IMPORTANT SAFETY RECALL NOTICE

**NHTSA Recall Number: 16V-100 School Bus
NHTSA Recall Number: 16V-101 Non-School Bus**

Subject: RECALL R16YL, Vision Starter Cable Routing W/CAT C707 Engines

Vision Starter Cable Routing

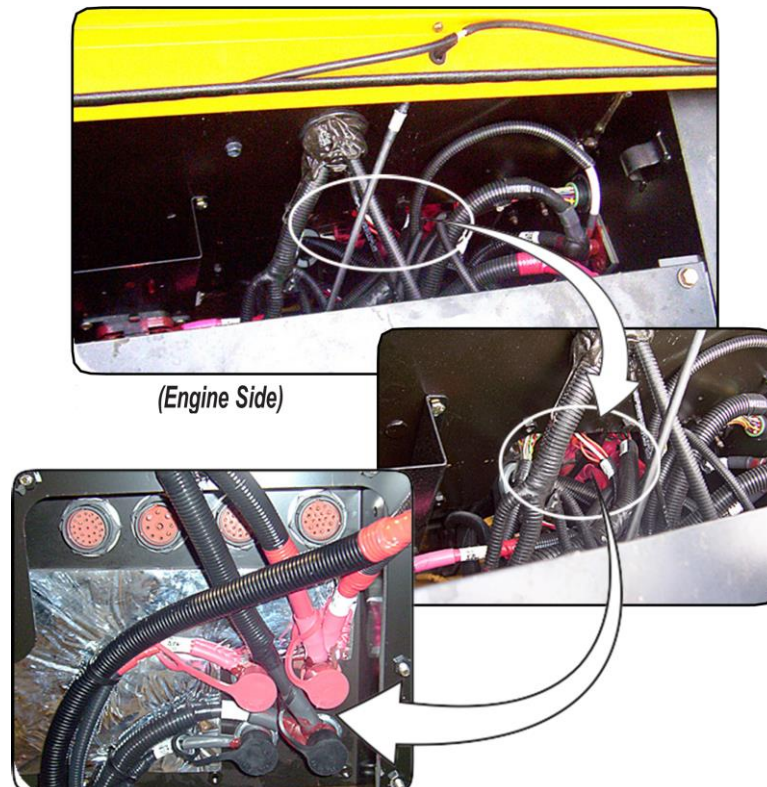
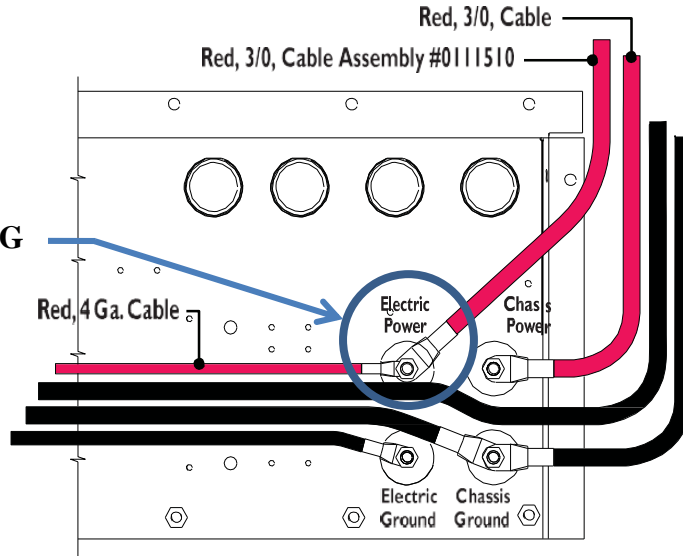
Starter cable may have been installed on the incorrect power stud which could cause the 4 gauge cable to be compromised during cranking process.

If starter cable is installed incorrectly, relocate starter cable from Electrical Power Stud to Chassis Power Stud. Inspect 4 gauge battery cable from Electrical Power Stud to battery for any damage and replace any damaged cable.

INCORRECT ROUTING

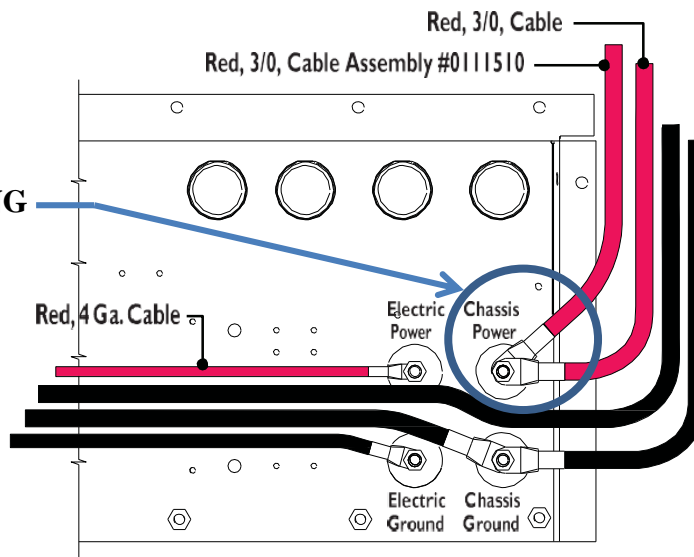
- The lower end of Cable Assembly 0111510 should be attached to the Chassis Power Stud. If the cable is in this location, no further action required. If the lower cable end is attached to the Electrical Power Stud, remove it and attach it to the Chassis Power Stud. (See figures below)
- Tighten both stud nuts to 11-15 ft.lbs. and apply a corrosion protection such as red glyptal.
